HOLIDAY INN PRO JZ19-24

HOLIDAY INN JZ19-24 WITH REZONING 18.730

PLANNING REVIEW

JZ19-24 PRO Concept Plan

HOLIDAY INN
DIMENSIONAL PLAN
HOLIDAY INN
SOUTH OF GRAND RIVER, EAST OF BECK ROAD

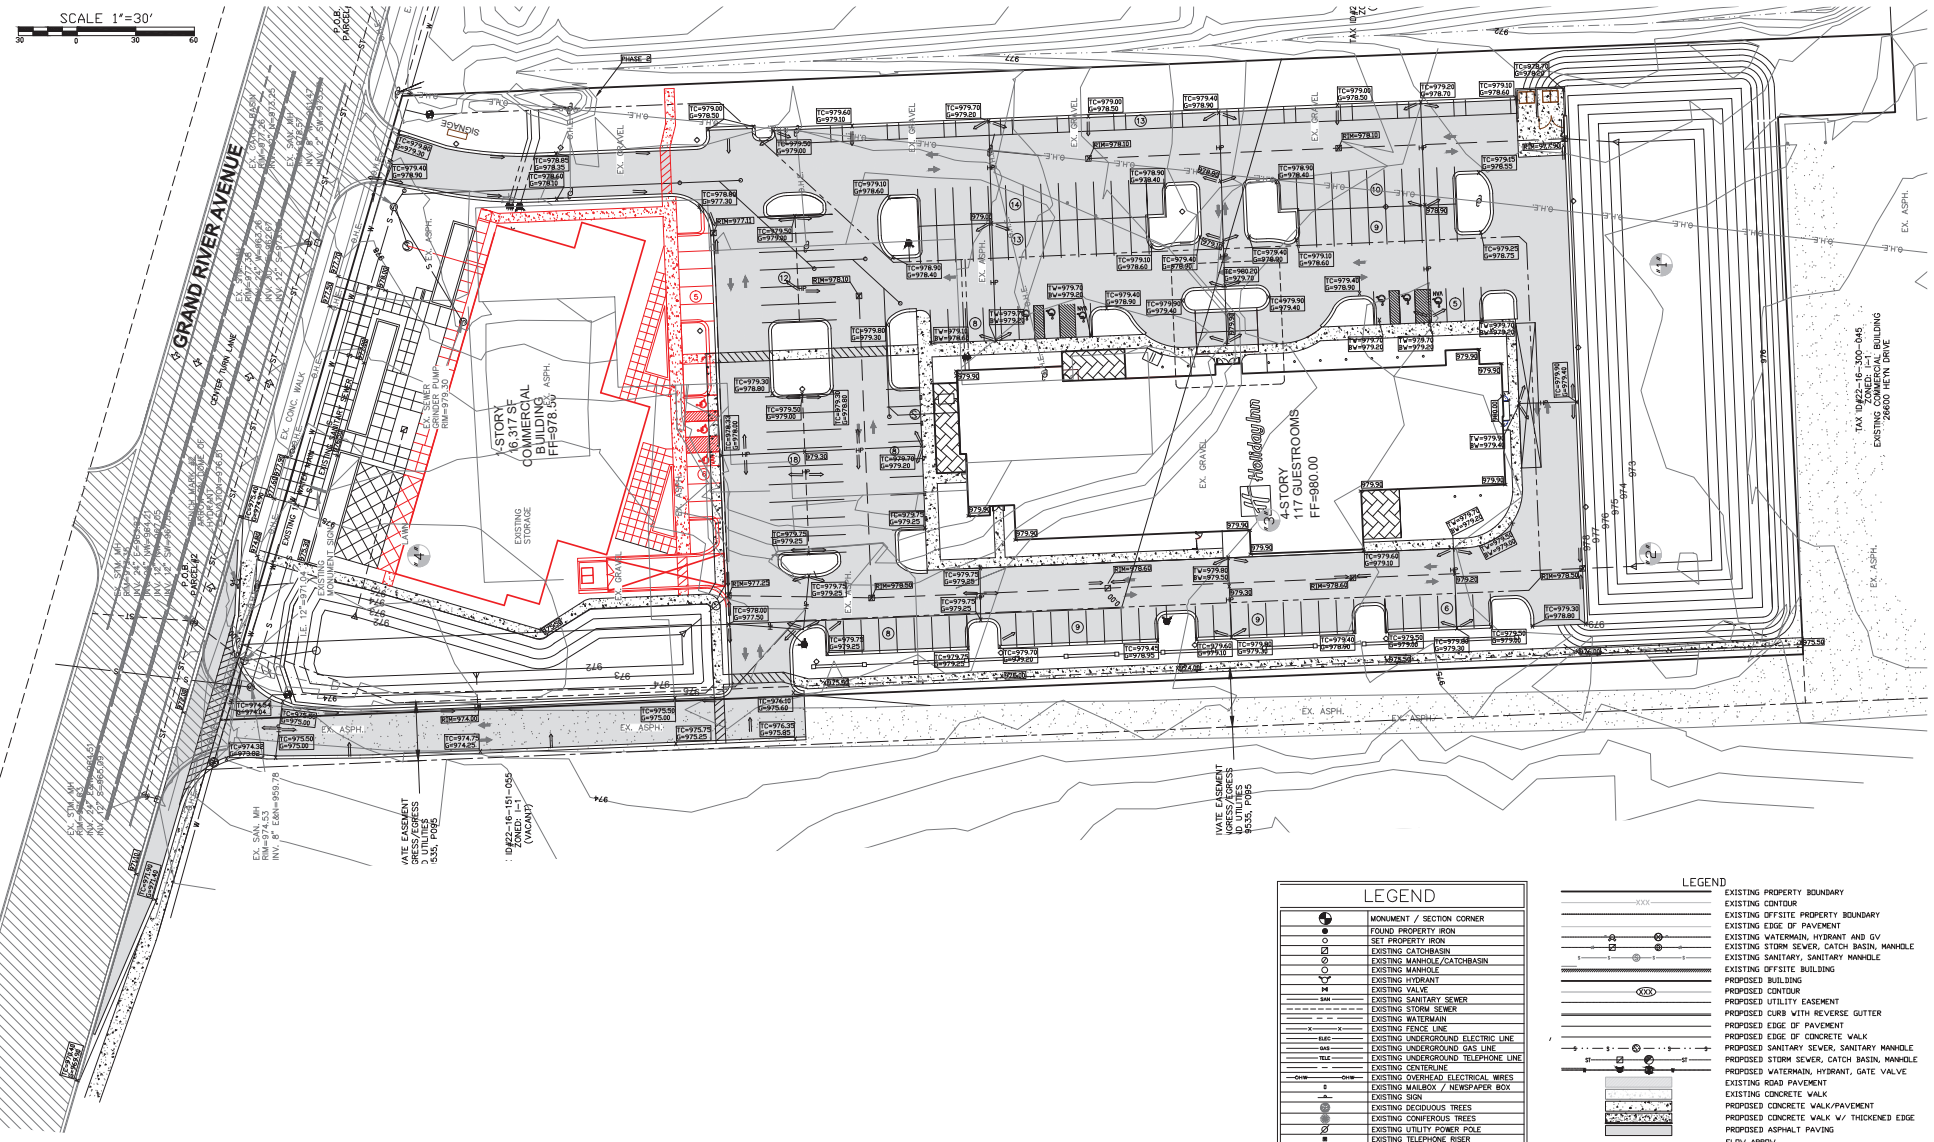
28. Revise the pavement cross sections on sheet S2 to conform to City's Design and Construction standards.
29. Detectable warning plates are required at all barrier free ramps, hazardous vehicular crossings and other areas where the sidewalk is flush with the adjacent drive or parking pavement. The barrier-free ramps shall comply with current MDOT specifications for ADA Sidewalk Ramps. Provide the latest version of the MDOT standard detail for detectable surfaces.

HOLIDAY INN UTILITY PLAN
 HOLIDAY INN
 SOUTH OF GRAND RIVER, EAST OF BECK ROAD

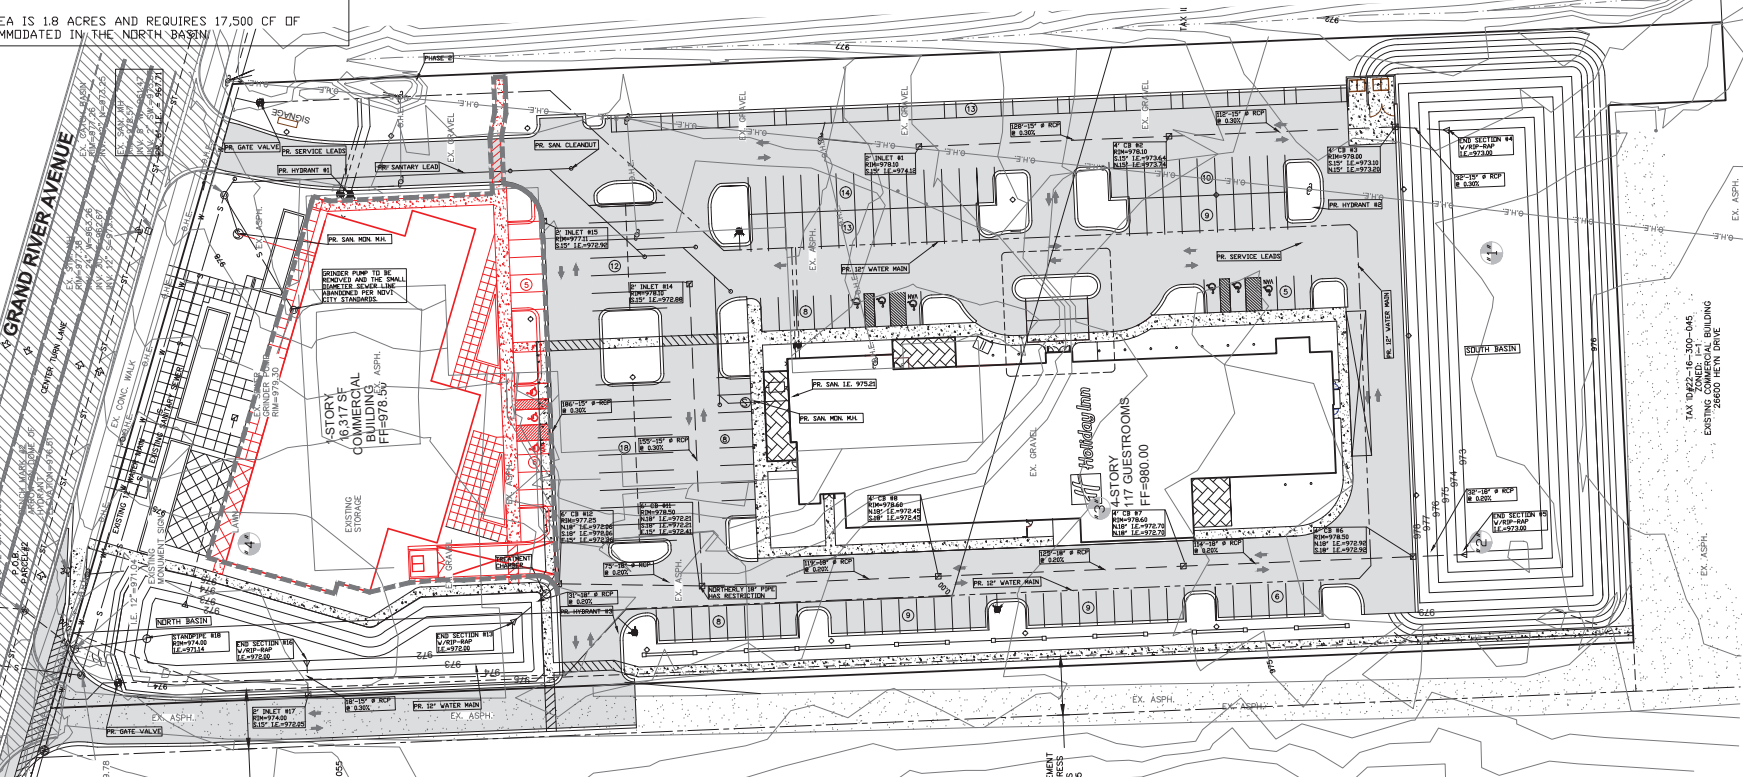
6. The test hole information is noted on sheet S4, but formal soil borings prepared by a geotechnical engineer shall be provided for a preliminary review of the constructability of the proposed development. Borings identifying soil types and groundwater elevation should be provided at the time of Preliminary Site plan.

19. The Storm Water Ordinance requires runoff from the entire development to be detained with post-development discharge restricted to 0.15 cfs/acre. Provide calculations to substantiate this intended agricultural rate noted on sheet S4.

S5

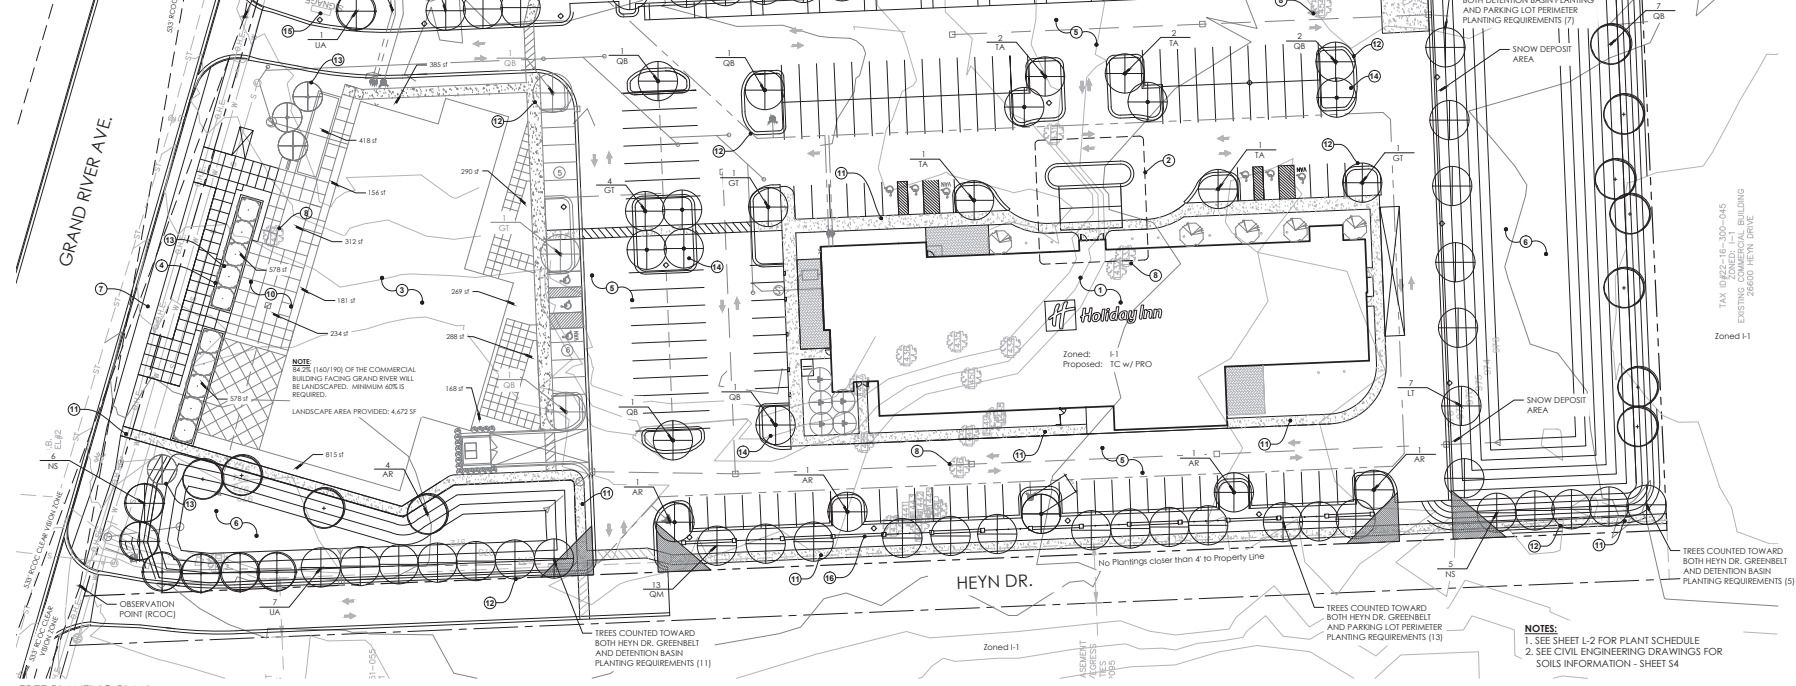
INTERNAL SITE OPERATIONS				
No.	Item	Proposed in the Plan	Compliance	Remarks
20	Parking space front curb height ZO 5.3.2	6" curb	Not Met	17' spaces are only permitted with 4" curb that has a 2' clear overhang. The detail on sheet 5 shows to use 4" for parking but the grading plan shows 6" curb abutting the 17' spaces.
21	Accessible parking – number ADA	9	Met	167 surface parking spaces provided, requiring 6 ADA spaces.
22	Accessible parking – size ADA	Not indicated	Inconclusive	Dimension ADA spaces and aisles
23	Number of Van-accessible space ADA	3 labeled, no dimensions	Inconclusive	3 van accessible spaces indicated, but dimensions are not provided to verify.
24	Bicycle parking			
24a	Requirement ZO 5.16.1	8 spaces provided, 4 at hotel, 4 at shopping center	Not met	Hotels require 4 spaces, as provided. Shopping centers require 2% of parking or 8 spaces, whichever is greater.
24b	Location ZO 5.16.1	2 location indicated	Not met	Spaces at hotel should be located within 120 feet of main entrance.

The detail for the dumpster enclosure on sheet S5 indicates “enclosure material to match the building material”. The dumpster enclosure is also required to be a minimum of 30% brick. Therefore, the note should be revised to read “brick to match the building”.
